Subject: **Pit 10 Drainage Reconfiguration, Alton Coal Development, LLC, Coal Hollow Project, Kane County, Utah, C/025/0005,**

Alton Coal Development, LLC (ACD) making this submittal to reconfigure the approved design drainage within Pit 10. During the implementation of the drainage control within Pit 10 it became apparent that Ditch P10-N01 could not be constructed as previously approved. Thus, Culvert P10-10 has been added to route runoff to Ditch P10-S03.

APPENDIX 5-2

UNDERGROUND FACILITIES & STRUCTURES DESIGN LAYOUT COAL HOLLOW PROJECT ALTON, UTAH DRAWING: 5-3C
--

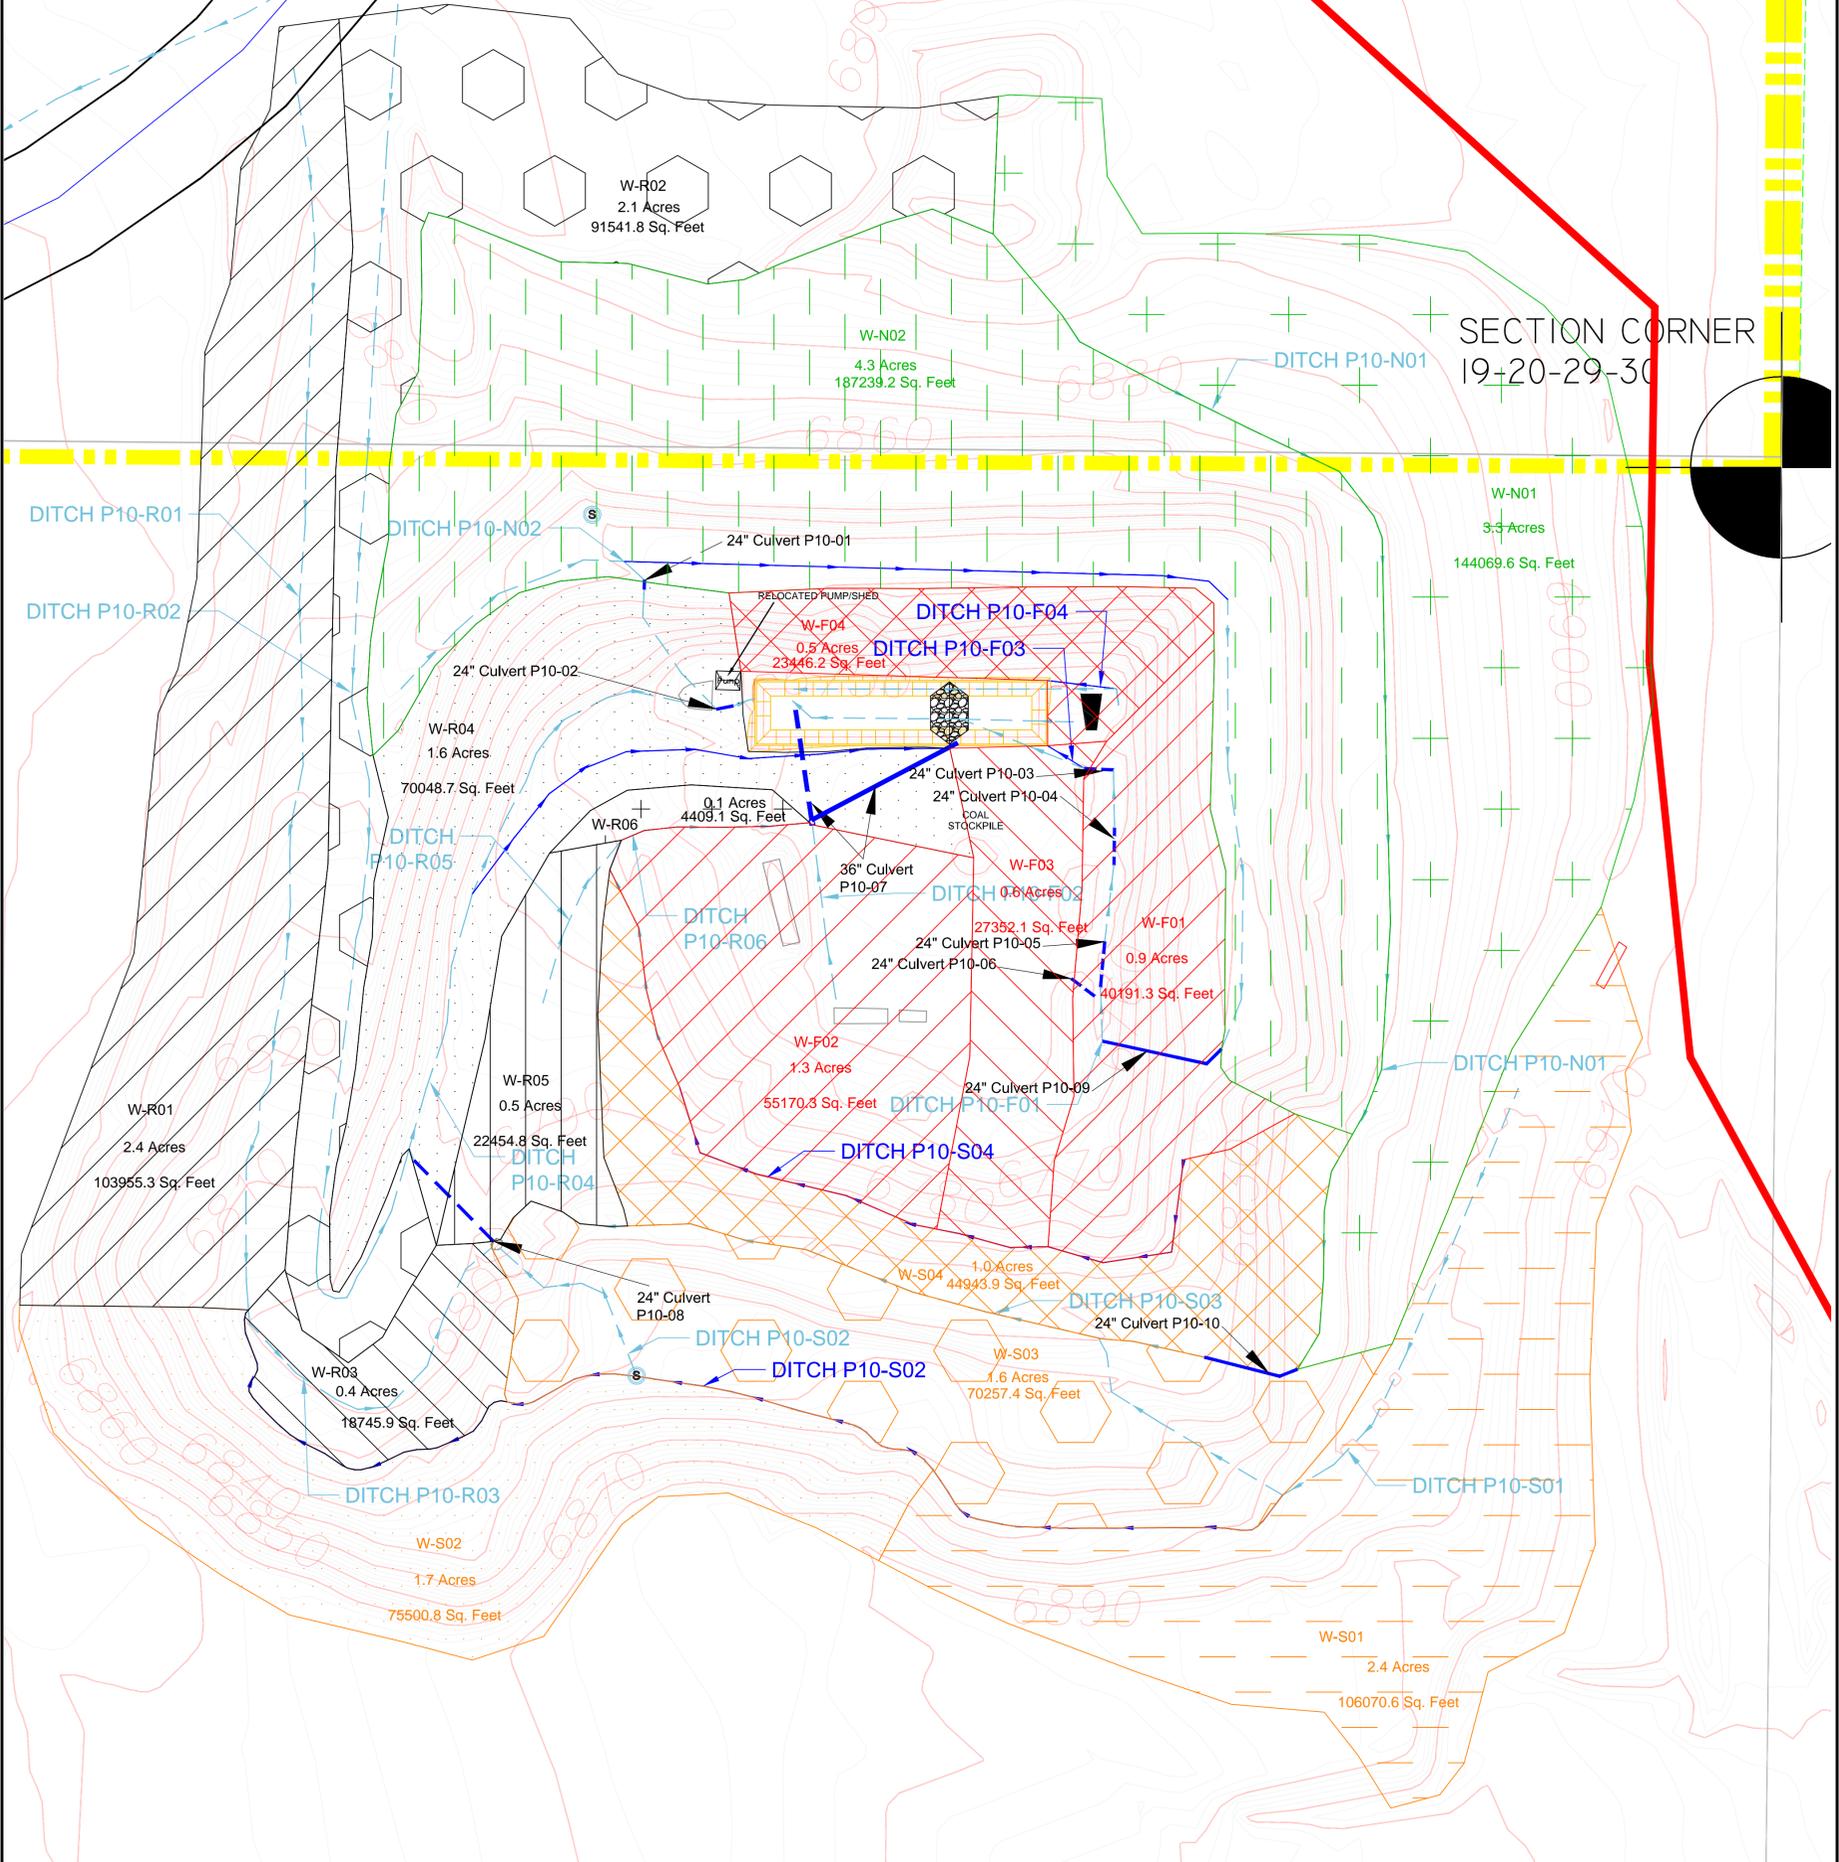
REMOVE 24" CULVERT P10-01 & CASCADING DRAINAGE OVER HIGHWALL

RELOCATE 36" CULVERT P10-07 & RELOCATE PUMP/SHED TO WESTERN EDGE OF SUMP

REMOVE CATCH BASIN & 24" CULVERT P10-02 THEN RE-ROUTE DRAINAGE PATH TO EAST SIDE OF SUMP

INSTALL EROSION PROTECTION P10-R04

INSTALL EROSION PROTECTION OUTLET OF CULVERT P10-09

INSTALL EROSION PROTECTION OUTLET OF CULVERT P10-08

UNCOVER INLETS/OUTLETS OF 24" CULVERTS UNDERNEATH PORTAL ENTRIES AND MAINTAIN ABILITY TO FLOW

REMOVE 24" CULVERT P10-06

REPLACE CASCADING DRAINAGE OVER HIGHWALL W/ CULVERT DROP-PIPE P10-09

REPLACE CASCADING DRAINAGE OVER HIGHWALL W/ CULVERT DROP-PIPE P10-10

INSTALL EROSION PROTECTION OUTLET OF CULVERT P10-10

REMOVE CASCADING DRAINAGE OVER HIGHWALL

REMOVE CASCADING DRAINAGE & RE-SHAPE CATCH BASIN TO ELIMINATE SEDIMENTATION
